2020 - 2021 Corvette - Service Update Bulletin: #N212327740: Service Update - HVAC Condensate Drain Hose Not Fully Installed - (Mar 10, 2021)

Subject: N212327740 — HVAC Condensate

Drain Hose Not Fully Installed

Models: 2020 – 2021 Chevrolet Corvette

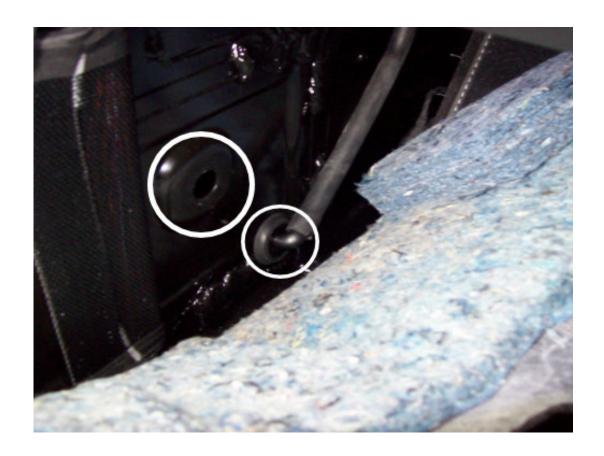
2. Pull back the carpet in the location shown to gain access to the A/C Evaporator Drain Tube.

- 3. The drain tube may be partially or fully disconnected from the body sheet metal as shown.
- If the drain tube end is fully disconnected, reinsert the drain tube end into the body sheet metal and press firmly to be sure it is securely fastened.
- If the drain tube end appears to be correctly seated in the body sheet metal, press firmly on it to confirm that it is securely fastened.
- Shift the carpet back to the original location.
- Reinstall the Front Floor Rear Console Side Trim Panel Right Side. Refer to *Front Floor Rear Console Side Trim Panel Right Side* in SI.
